Interactive comment on “Observational gridded runoff estimates for Europe (E-RUN version 1.0)” by Lukas Gudmundsson and Sonia I. Seneviratne

H. Müller Schmied (Referee)

Received and published: 7 February 2016

Fig. 1. Long term average cell runoff for the years 1979-2008 for E-RUN 1.0 (left), same for WaterGAP 2.2 (STANDARD, center), and differences (E-RUN – WaterGAP, right); all values in mm/yr.

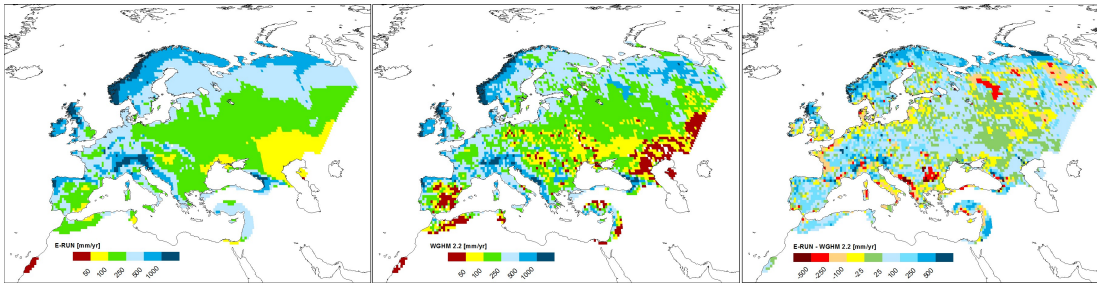
I investigated the 30 years between 1979 and 2008 (I selected time period using Climate Data Operators), calculated monthly sums (ignoring leap years) and visualized long term average runoff in mm/yr. During that, I recognized that values are not available for all grid cells and each month (compare the Figure 1 here against e.g. your Fig. 9). For example, the last years of Iceland are missing, which I guess is due to the missing climate observation data. There are also other grid cells affected (e.g. Turkey). I suggest to describe in the manuscript that data are discontinuous for some regions/grid cells.

I could not resist to compare the long term average runoff with those from WaterGAP 2.2 (STANDARD, see Müller Schmied et al., 2014). Figure 1 shows (for all grid cells that contain values in every month of E-RUN) the long term average of E-RUN, WaterGAP 2.2 as well as the absolute differences. I was so interested, as WaterGAP is calibrated against the long term average river discharge (from GRDC database) for many basins in Europe, and that could be some kind of “fair” comparison. This is not completely the case, as station correction factor CFS in WaterGAP (see Müller Schmied et al., 2014) is applied only at the grid cell where the calibration station is located (and cannot be meaningful back-transferred to the basin itself). The comparison is also not “fair” as climate forcing differs (E-OBS for E-RUN, WFDEI for WaterGAP). Anyhow, the broad pattern is comparable, and in many regions, differences are within ± 100 mm/yr.
